# Access Compliance Report

## Public Rights-of-Way

### (Curb Ramps)

Intersection ID: 28069	Main Street: PROVIDENCE_RD_WEST	Cross Street: WYNDHAM_OAKS_DR	Location: NE
ADA ID: CFA33E8B7FC3	Ramp Type: PerpDiag	Initial Pass/Fail: Fail	Overall Compliance: No
Severity Score: 12.5			
Codes/Mitigation Info/Possible Solution		Field Measurements/Component Compliance

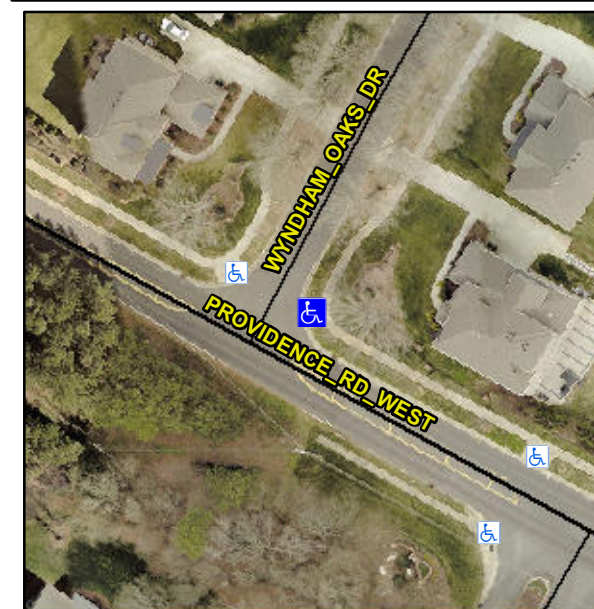
**Not Found, R304.5.3**

Compliance	Description	Data	Compliance	Description	Data
N/A	Ramp Length (in)	88.0	Yes	Ramp Slope (%)	7.0
Yes	Ramp Width (in)	48.0	No	Ramp XSlope (%)	5.8
N/A	Flare Type LT	N/A	N/A	Flare Type RT	N/A
N/A	Flare Slope LT (%)	N/A	N/A	Flare Slope RT (%)	N/A
N/A	Flare Traversable LT?	N/A	N/A	Flare Traversable RT?	N/A
N/A	Landing Length (in)	N/A	N/A	DWS Provided?	N/A
N/A	Landing Width (in)	N/A	N/A	DWS Contrast?	N/A
N/A	Landing Slope (%)	N/A	N/A	DWS Length (in)	N/A
N/A	Landing X Slope (%)	N/A	N/A	DWS Full Width?	N/A
N/A	Landing Curb? (Y/N)	N/A	N/A	DWS Offset (in)	N/A
N/A	Shared Landing?	N/A			
N/A	Gutter Ponding?	N/A	N/A	Gutter Slope (%)	N/A
N/A	Gutter Lip Ht (in)	N/A	N/A	Gutter X Slope (%)	N/A
N/A	Painted X Walk1?	No	N/A	Painted X Walk2?	No
	X Walk 1 Direction	To NW		X Walk 2 Direction	To SW
N/A	X Walk 1 Width (in)	N/A	N/A	X Walk 2 Width (in)	N/A
	X Walk 1 Slope (%)	2.9		X Walk 2 Slope (%)	1.3
	X Walk 1 X Slope (%)	0.9		X Walk 2 X Slope (%)	2.9

**Remove & Replace Curb Ramp With Two New Directional Ramps or Equivalent.**
